RECALL SERVICE BULLETIN

DATE ISSUED	MODEL YEAR(S) AFFECTED	RSB #
12/02/2016	2016, 2017	468

Subject: Recall Campaign No.: 16V 773

How to Replace Motor on Single Tube Wardrobe Slideout

Disconnecting and Removing the Motor without a Brake

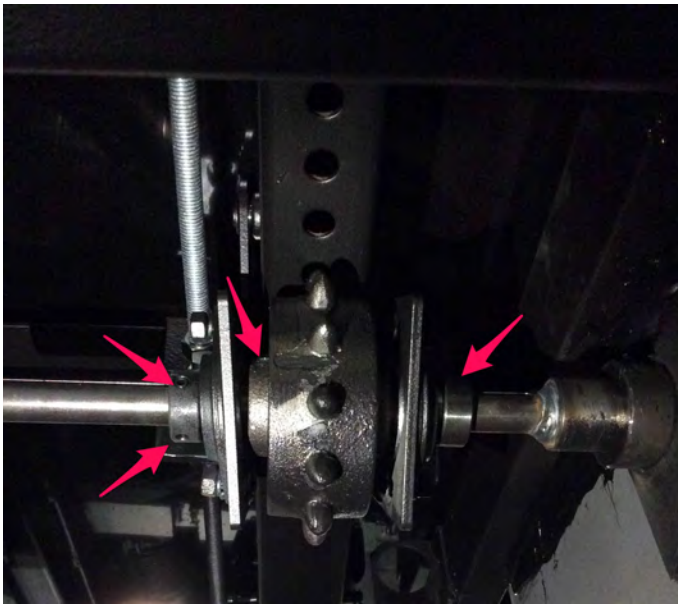
1. Disconnect the wires, and loosen the tran torque bushing.
2. Remove the four motor mounting bolts, followed by the motor.

Loosening the Shaft Components

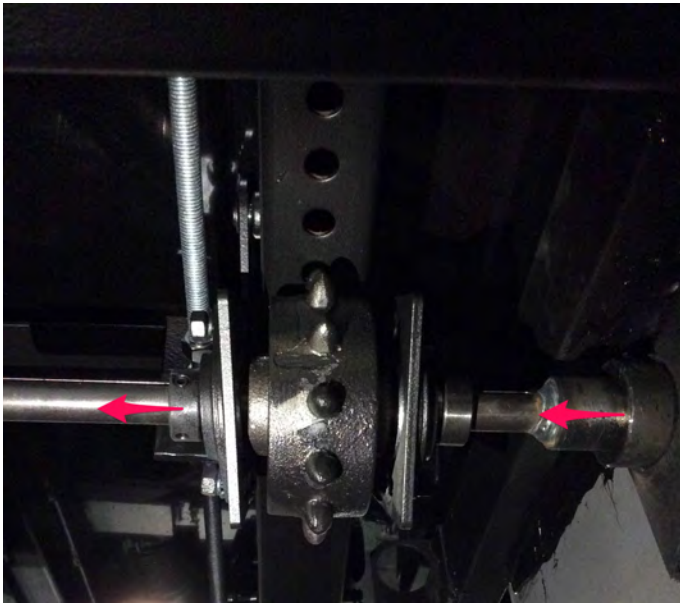
3. Loosen the set screws located at the cog wheel.
4. Loosen the set screws located at both of the bearing retainers.

Preparing for the New Motor

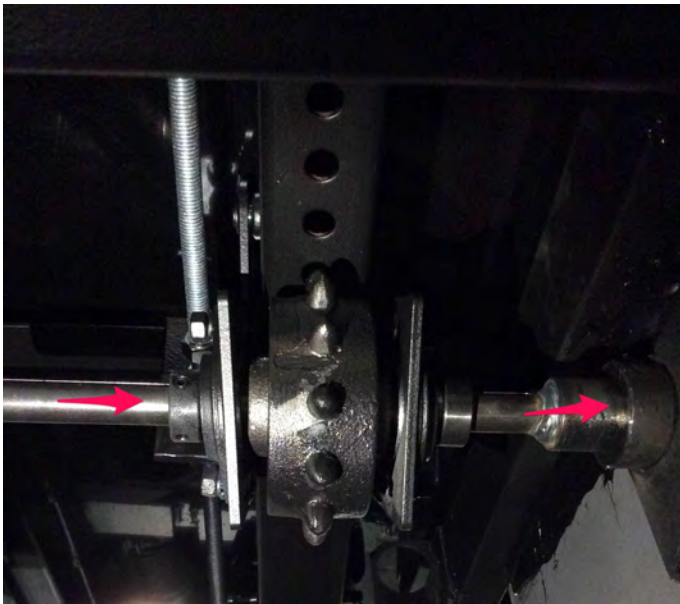
5. Slide the shaft over to allow the new motor to be mounted. If the shaft cannot be moved over, loosen the rubber around it.

6. Slide the shaft over, then place new rubber around the shaft.

7. Slide the trantorque bushing onto the shaft of the new motor.

Installing the New Motor

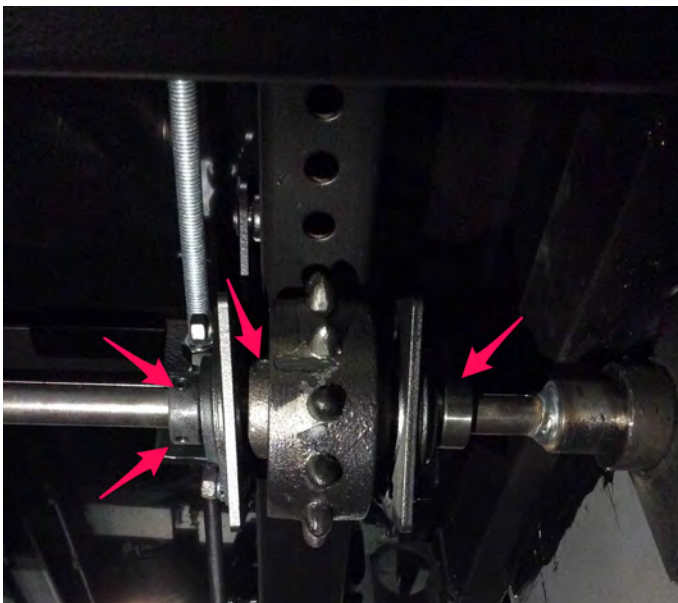
8. Install the new motor with the brake.

9. Temporarily mount the motor with two bolts with nuts and washers on the brake side. Note: Make them finger-tight (only the two will line up, as the bolt mounting holes will not align with the new motor).

10. Slide the shaft back over so that it will fully engage with the trantorque bushing. Make sure it is snug to align the motor and shaft.

11. Snug up the two motor mounting bolts.
12. Drill a 3/8" hole through the remaining motor mount bolt holes into the mounting plate.
13. Install the two remaining bolts, nuts, washers. Then tighten them.
14. Torque all four mounting bolts to 33 ft. lb., and torque the transtorque bushing to 175 ft. lb.
